| Office Action Summary | Application No. 10/673,680 | Applicant(s) DOUBLER ET AL. | |

DETAILED ACTION

FIG. 14

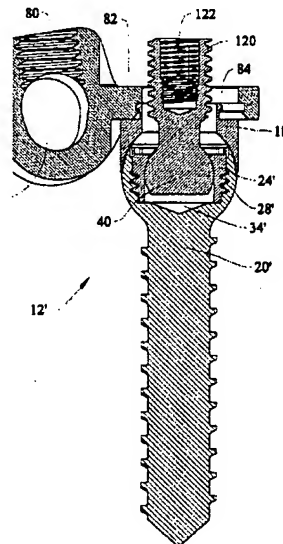
In addition to the bone screw of Fig. 2 having a substantially spherical second end (opposite the threaded portion), Mullane also discloses a support collar (18), with a substantially spherical first surface and a generally flat second surface both of which aid

in providing a clamping force for locking the linking element. See Fig. 14 above. Mullane further discloses a collet member (24') with a tapered inner compression surface (see Fig. 14 above), and also a linking member tensioning means that has an internal bore with threads (122) that is capable being gripped by a threaded attachment to provide the necessary tensile force with respect to the collet.
